STAFF RECOMMENDATION
400 Broadway
December 21, 2016

Application: New construction—alteration to previously approved addition
District: Broadway Historic Preservation Zoning Overlay
Council District: 19
Map and Parcel Number: 09306308200
Applicant: Joshua Hughes, Tuck Hinton
Project Lead: Melissa Baldock, melissa.baldock@nashville.gov

<p>Description of Project: Application is to alter the design of previously-approved rooftop addition by increasing the height.</p> <p>Recommendation Summary: Staff recommends approval of the alteration to the rooftop addition, finding that it meets Section III. of the <i>Broadway Historic Preservation Zoning Overlay: Handbook and Design Guidelines</i>.</p>	<p>Attachments A: Photographs B: Site Plan C: Elevations</p>
---	--

Figure 1. 400 Broadway.

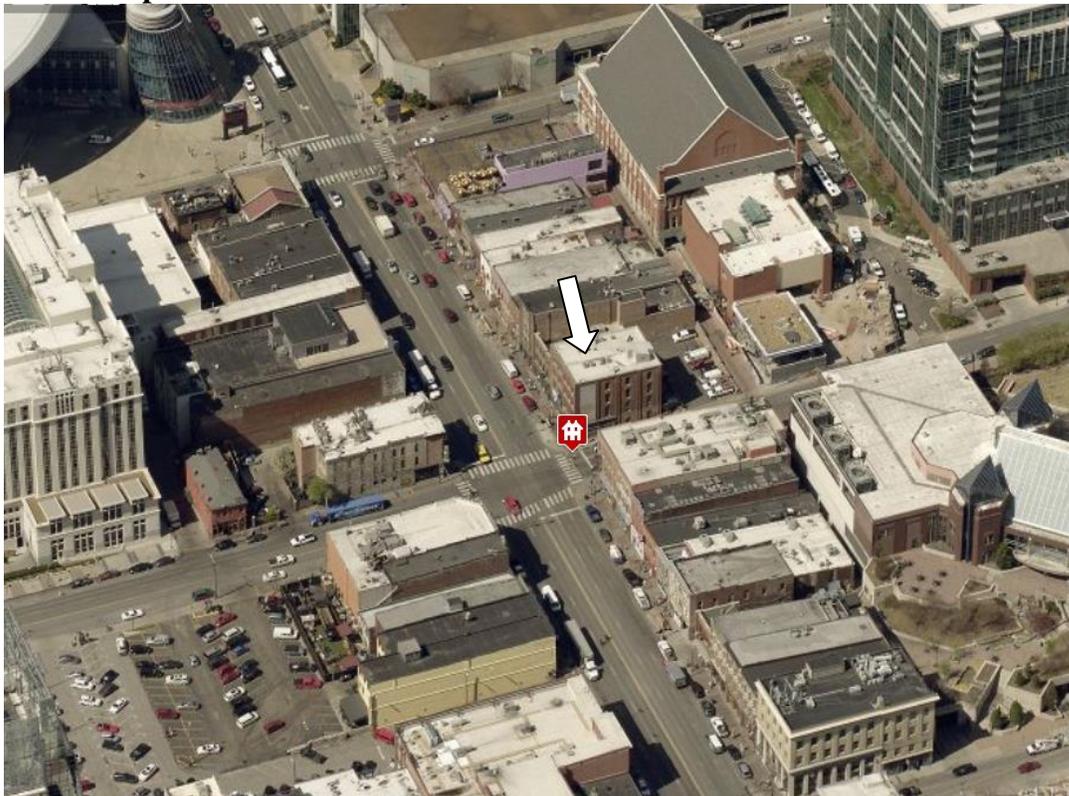
Background: 400 Broadway is a c. 1870 brick commercial structure that contributes to the Broadway Historic Preservation Zoning Overlay (Figure 1). The western-most portion of the building was altered in the early to mid-twentieth century with new window openings and steel windows. The building was altered again in 1990. The storefronts date to that restoration. In July 2016, the Historic Zoning Commission approved alterations to the building's storefronts, new lighting, and a rooftop and rear addition. In October 2016, the Commission approved a revised, larger version of the addition that was approved in July 2016. In that approval, changes were made to the size and location of the stair bulkheads. This application seeks to change the size of the previously-approved rooftop addition by extending the height of the elevator overrun.

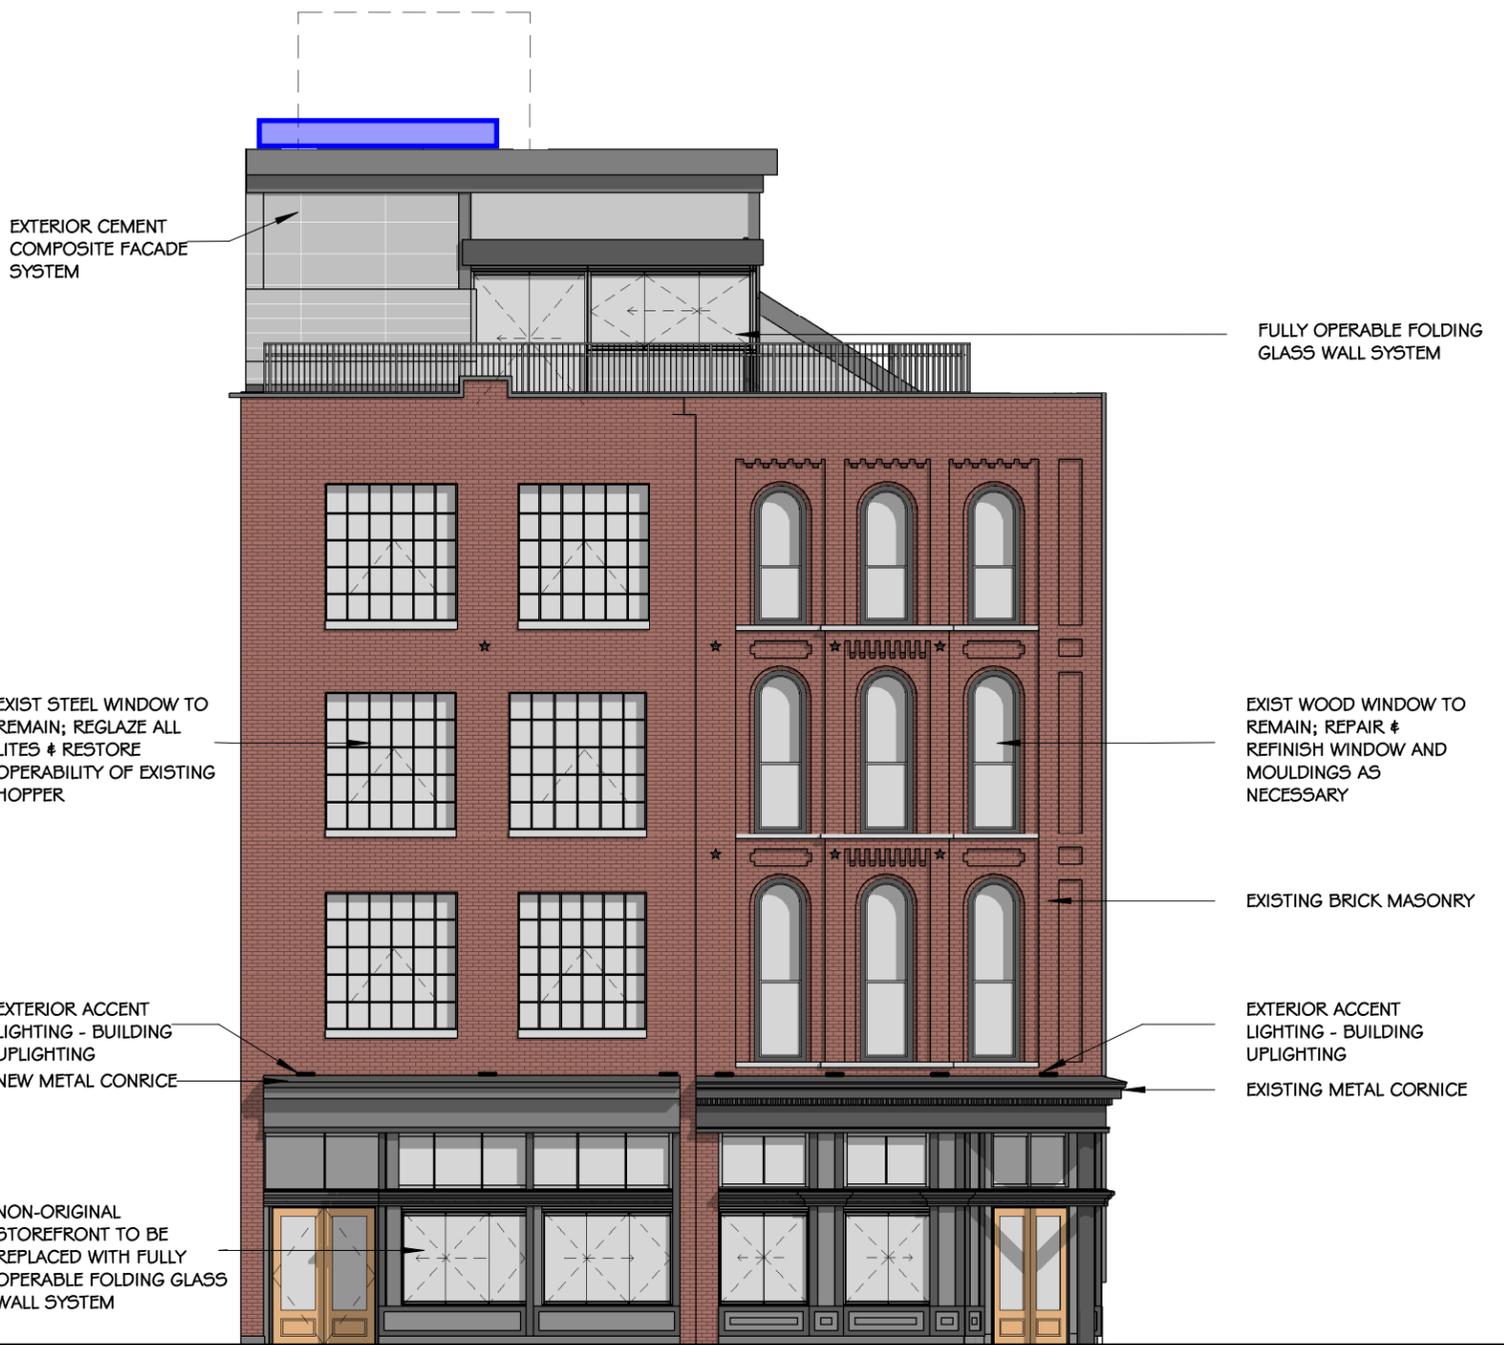
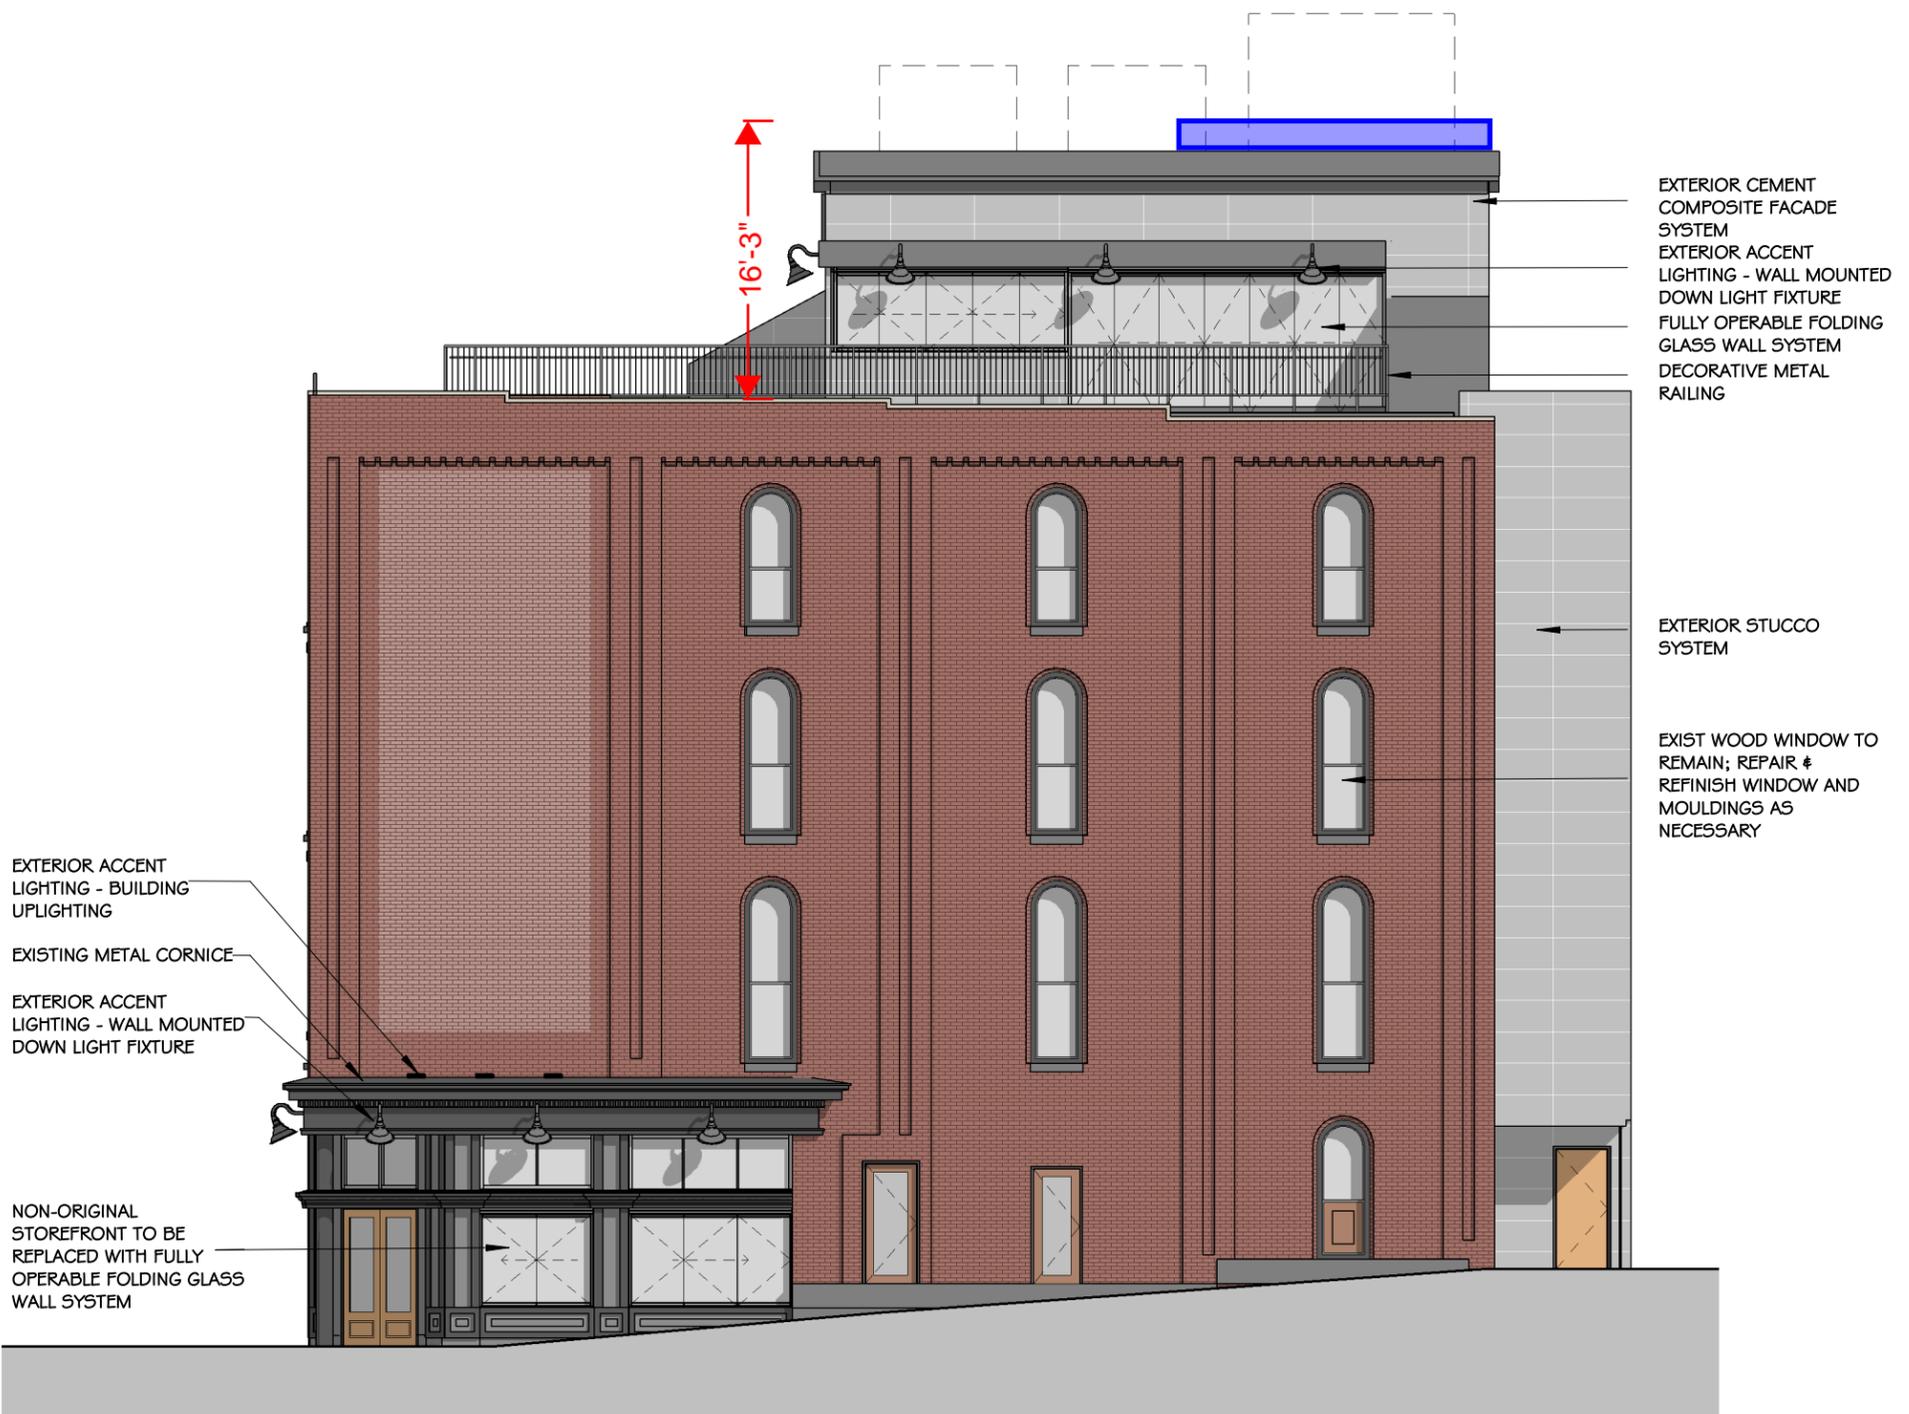
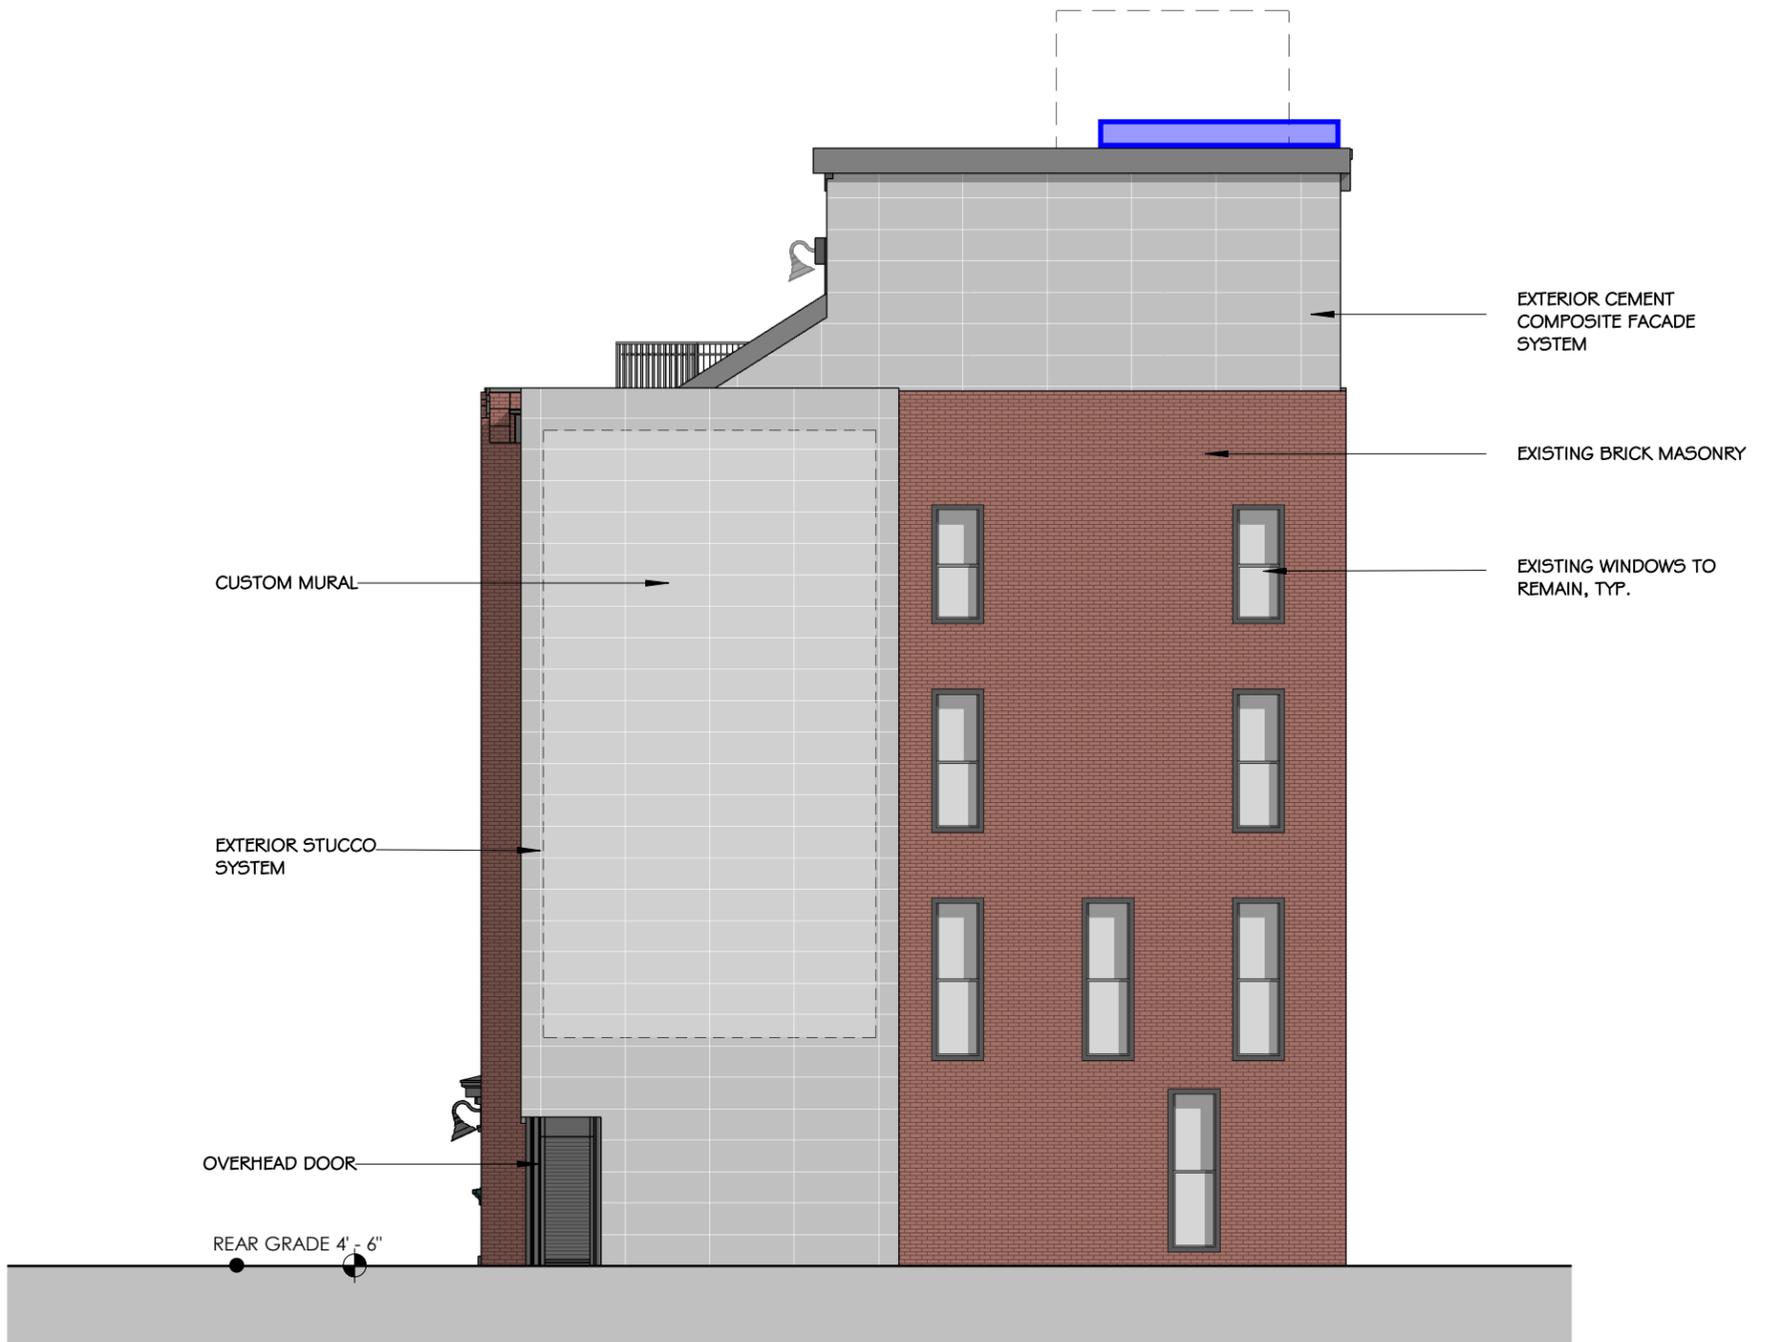
Rooftop Addition: The height and scale of the main portion of the rooftop addition and rear addition have not changed since the Commission voted to approve the project, with conditions, in July and again in October 2016. However, the applicant's engineer has recommended that the building should have a traction elevator rather than a hydraulic elevator because of the size of the building and likely amount it will be used. While the traction elevator is more reliable, it requires a larger overrun than a hydraulic elevator. The traction elevator will require that a portion of the addition will be sixteen feet, three inches (16'3") taller than the historic roof parapet. This is one foot, three inches (1'3") taller than what the design guidelines allow. The taller portion will be about ten foot, six inches (10'6") wide and thirteen feet, nine inches (13'9") deep. It will be pushed back from the Broadway façade nearly fifty-five feet (55') and from the Fourth Avenue North façade nearly thirty-nine feet (39'). Staff finds that the additional one foot, three inches (1'3") of height for the elevator overrun to be acceptable, in this instance, because it is located so far back from the facades and is modestly scaled. It will likely be at most minimally visible.

Staff therefore finds that the alterations to the previously approved rooftop addition meet Section III.H. of the Broadway Historic Preservation Zoning Overlay design guidelines.
